BAR 03-08-06
1415 University Avenue
Tax Map 9 Parcel 75
Renovation of Façade
Qdoba Mexican Grill, Applicant/ Bayus-Evola Architects

**CITY OF CHARLOTTESVILLE
BOARD OF ARCHITECTURAL REVIEW
STAFF REPORT
August 19, 2003**

BAR 03-08-06
1415 University Avenue
Tax Map 9 Parcel 75
Renovation of Facade
Qdoba Mexican Grill, Applicant/ Bayus-Evola (Ed Cooke), Architects

For BAR review Aug 19, 2003

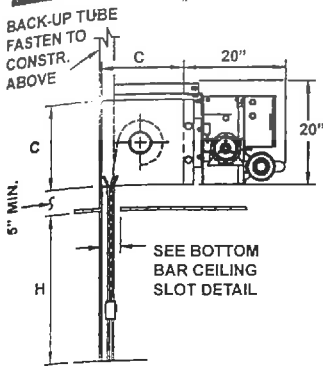
The BAR unanimously denied the use of the glazed grills based on Design Review Guidelines for façade improvements, # 8.

The BAR unanimously denied the proposal to remove the remaining marble based on Design Review Guidelines for façade improvements, # 4, and required that the missing marble be replaced with marble that matches the existing, subject to staff approval.

Remaining concerns are preserving the historical features of the building (marble base in particular); allowing the architectural features to show (triglyphs on entablature where sign will be located); and compatibility of the design with the district (glazed grills in particular). Signage should also be discussed.

In 1998 the BAR wanted the missing marble to be more closely matched or replaced entirely. It is unclear what was actually implemented – 1998 file photos show that a small piece of marble was missing on the lower right side of the building. Staff recommends retaining the original marble on the left side and replacing the original marble or matching the marble on the right side.

VISTAGARD™ GLAZED ROLLING GRILLES

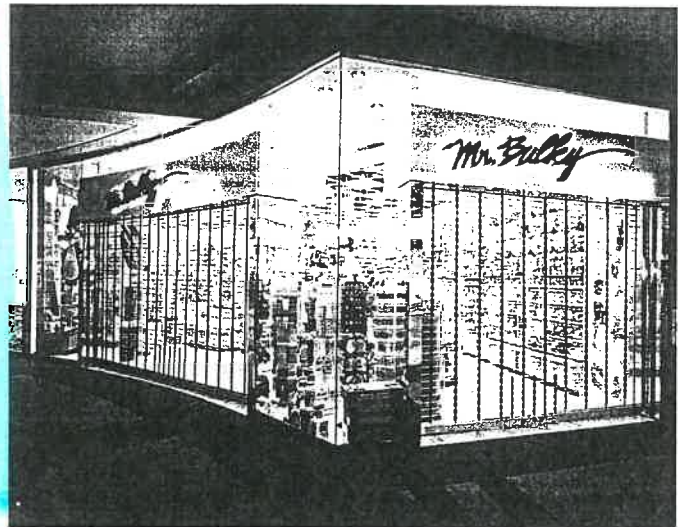
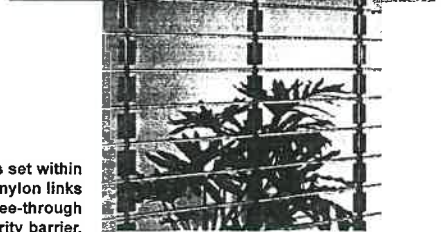
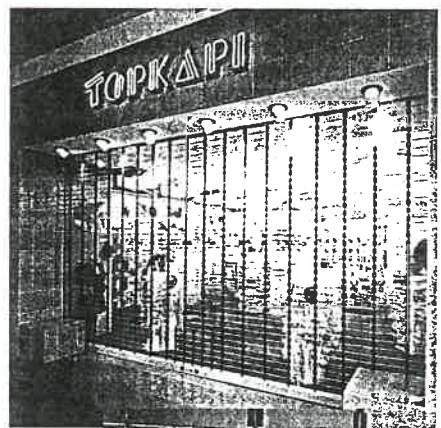
Staff recommends against the proposed glazed grills as being incompatible to the building. There may be an alternate solution, such as glazed folding shutters, similar to the doors on Escafe Restaurant downtown that are left open during good weather. Staff would not be adverse to another type of roll-down shutter, if the design is compatible.

I am not recommending approval of the grill as proposed. Do you have alternatives for the BAR to consider?
